RS-20-012
January 29, 2020U.S. Nuclear Regulatory Commission
ATTN: Document Control Desk
Washington, DC 20555-0001Braidwood Station, Units 1 and 2
Renewed Facility Operating License Nos. NPF-72 and NPF-77
NRC Docket Nos. STN 50-456 and STN 50-457Subject: Response to Request for Additional Information Regarding Relief Request
Associated with the Third Ten-Year Inservice Inspection Program Interval

ATTACHMENT 1
Additional Information Supporting
10 CFR 50.55a Relief Request I3R-18

Figure 1. Indication Plot Sheet for the Preservice Examination of Weld 1SI-39-25

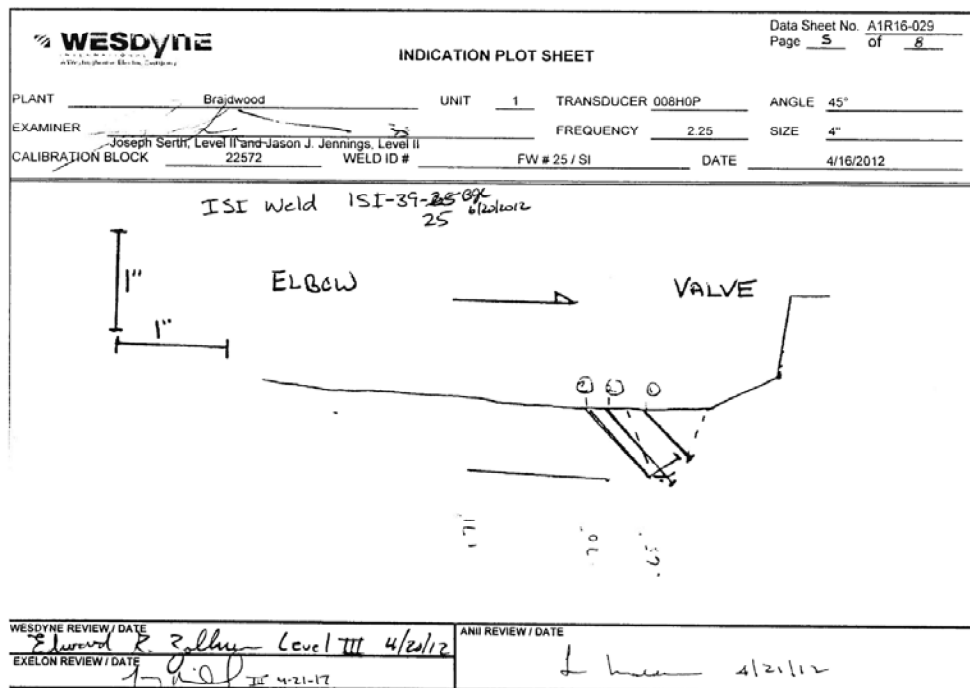
Braidwood, Unit 1 weld 1SI-39-25 is identified as having received a limited examination (i.e. only 50% of the required examination volume was examined), and two flaws were identified. Given this information, provide justification that the structural integrity of Braidwood, Unit 1 weld 1SI-39-25 is assured. Without additional information, the NRC staff is unable to evaluate the impracticality of meeting the ASME Code requirements, whether alternatives should be imposed, and whether an augmented inspection program or other action is needed for added assurance of structural reliability.

Figure 1 below, provides the flaw indication plot for the subsurface (embedded) flaw for the preservice examination of weld 1SI-39-25. Indications 1 and 3 on the plot are the same flaw with Indication 1 detecting the flaw in the downward 45-degree angle and Indication 3 detecting the same flaw in the upward direction after bouncing off the inside diameter surface. Indication 2 is an inside diameter geometric reflector and not indicative of a material discontinuity.
